Product Change Notification Number: PDF-SF004

Title: Adesto[®] Serial Flash & DataFlash[®] Products Package Marking Change		
Product Identification: All Adesto [®] Serial Flash and DataFlash Packages		
Reason for Change:	<input type="checkbox"/> Material / Composition <input type="checkbox"/> Processing / Manufacturing	<input type="checkbox"/> Design / Firmware <input checked="" type="checkbox"/> Logistics <input type="checkbox"/> Manufacturing Location <input type="checkbox"/> Quality / Reliability
Change Description:		
<p>Serial Flash & DataFlash Product Line Package Marking Change.</p> <p>As previously communicated, (ATMEL PCN SC124101), Adesto Technologies Corporation acquired Atmel's Serial Flash and DataFlash product lines on Oct 1st, 2012. As part of the transition, Adesto is replacing the Atmel name on newly assembled parts with "adesto". The parts include:</p>		
Table 1. Affected Parts		
Density	Serial Flash (DataFlash)	Serial Flash (BIOS Flash)

Table 2: Adesto Top Marked Package Summary

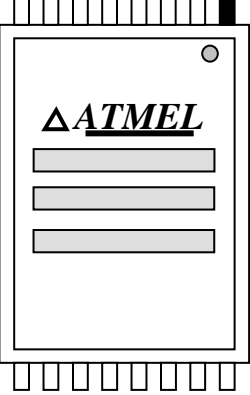
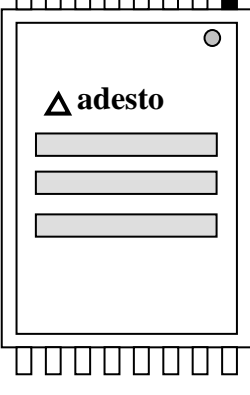
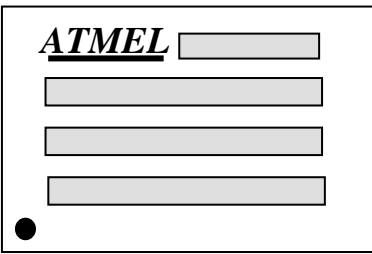
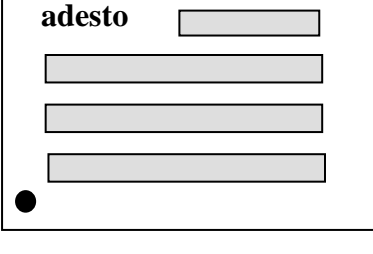
Beginning March 31st, 2013 Adesto will begin shipping parts with the "adesto" name as described below and in Appendix A. Note: Due to inventory already in assembly and inventory held by the Adesto franchised sales channel pipeline prior to this notice, customers are advised that product may be received with either the original Atmel marking or the new "adesto" marking. This marking change will affect the following package options and combinations for all active part numbers including Customer Applied Numbers (CAN's) effective from **March 31st 2013**.

Identification Method to Distinguish Change: Adesto name will be marked on the topside of the device			
Qualification Data:	<input type="checkbox"/> Available	<input type="checkbox"/> Will be available (mm/dd/yr):	<input checked="" type="checkbox"/> Not Applicable
Samples:	<input type="checkbox"/> Available	<input type="checkbox"/> Will be available (mm/dd/yr):	<input checked="" type="checkbox"/> Contact Factory
Quantifiable Impact on Quality & Reliability: None			
Proposed First Ship Date*: March 31st 2013			
<p><i>* The Proposed First Ship Date is the forecasted date that a customer may expect to receive changed product. This is determined by the estimated date of inventory depletion on the PCN issue date. This may be affected by fluctuations in supply and demand. Consequently, although customers should be prepared to receive changed product on this date, Adesto will continue to ship pre-changed product until a time in which inventory has been depleted. This may result in pre-changed product being shipped to customers after this forecasted date.</i></p>
